Product Change Notification (PCN)

PCN Number: PCN_ConTBL3_20260916 Affected Series: WR-TBL Affected Part Number: see table "PART NUMBER, REVISION & DATASHEET" PCN Date: 2026-06-16 (YYYY-MM-DD) Effective Date: 2025-09-16 (YYYY-MM-DD)	Change Category: ☐ Equipment/Location ☒ General Data ☐ Material ☐ Process ☐ Product Design ☐ Shipping/Packaging ☐ Supplier ☐ Software
Contact: Product Management Phone: +49 (0) 7942 - 945 5001 Fax: +49 (0) 7942 - 945 5179 E-Mail: pcn.eican@we-online.com	Datasheet Change: ☒ Yes ☐ No Attachment: ☐ Yes ☒ No

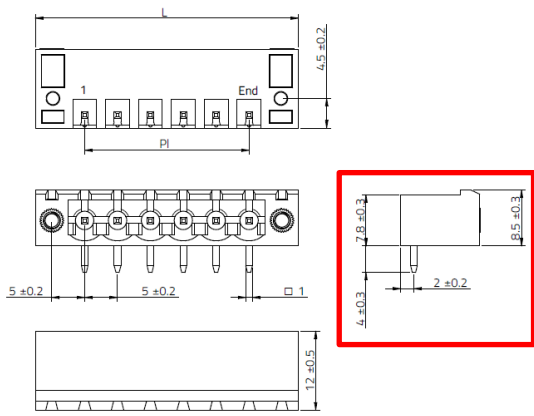
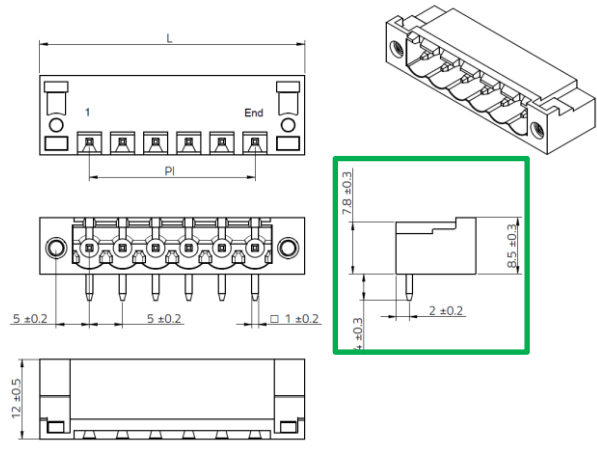
This is a datasheet correction only. There will be no change in fit, form, function, quality or reliability of the product. The preliminary datasheets of the affected part numbers which are available in the online catalogue will be available on the website after the PCN date. Link to the website: [WR-TBL](#)

- 6913177100xx**

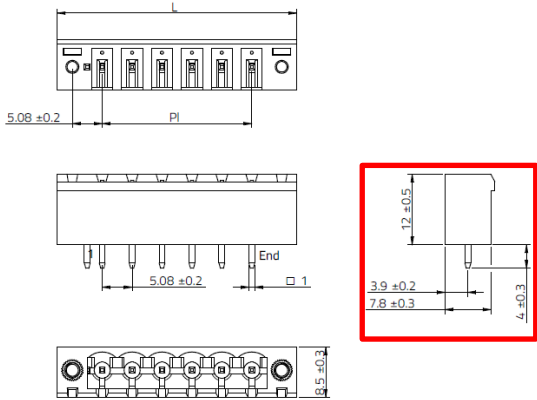
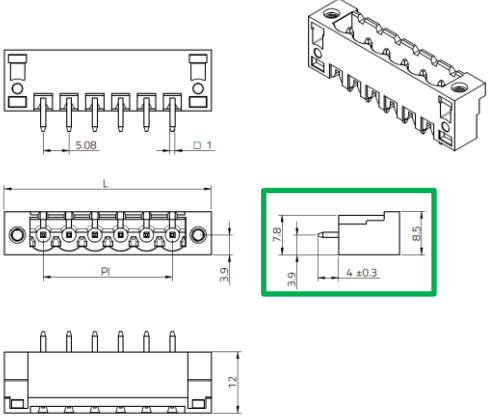
BEFORE	AFTER
